IHO TRANSFER STANDARD for DIGITAL HYDROGRAPHIC DATA

Special Publication No. 57

**S-57 MAINTENANCE DOCUMENT
(Cumulative)**

Number 8 – March 2002

figure 2.4

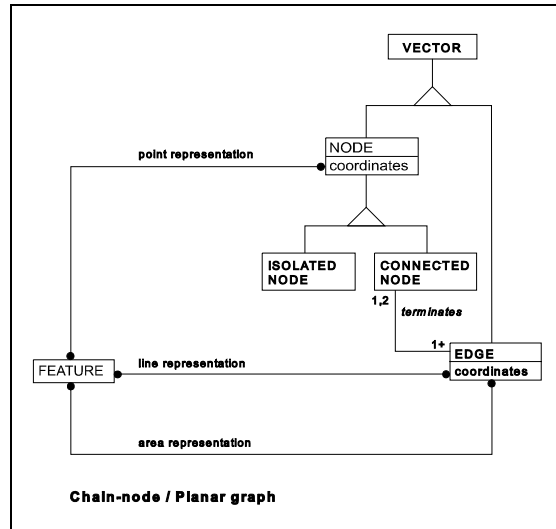
- 1.Cl.2 The data model for chain-node states that a point representations are coded as either isolated or connected nodes. Figure 2.4 implies that they can only be isolated nodes. The text description of the model is correct and should be taken as the authority. Figure 2.4 will be corrected in the next version of S-57. (See also [1.Co.2](#)).
- 4.Cl.1 The statement that "Duplication of coincident linear geometry is prohibited" is incorrect for the chain-node data model. Coincident geometry can be duplicated if it is considered that there is no logical topological relationship between objects. (See also [4.Co.3](#)).

- 1.Cl.3 The data model for planar-graph states that a point representations are coded as for chain node i.e. they can be either isolated or connected nodes. Figure 2.4 implies that they can only be isolated nodes. The text description of the model is correct and should be taken as the authority. Figure 2.4 will be corrected in the next version of S-57. (See also [1.Co.2](#)).

1.Co.2 Replace Figure 2.4 with the following diagram (See also [1.CI.2](#) and [1.CI.3](#)).

figure 2.5

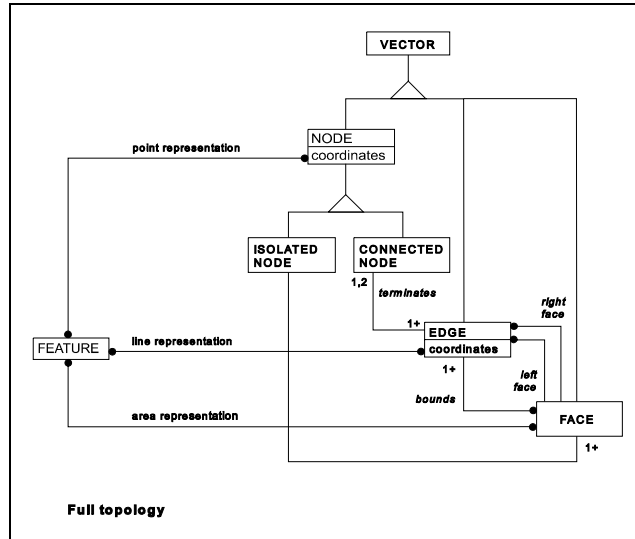
- 1.Cl.4 The data model for full topology states that a point representations are coded as for planar graph i.e. they can be either isolated or connected nodes. Figure 2.5 implies that they can only be isolated nodes. The text description of the model is correct and should be taken as the authority. Figure 2.5 will be corrected in the next version of S-57. (See also [1.Co.3](#)).

1.Co.3 Replace Figure 2.5 with the following diagram (See also [1.Cl.4](#)).
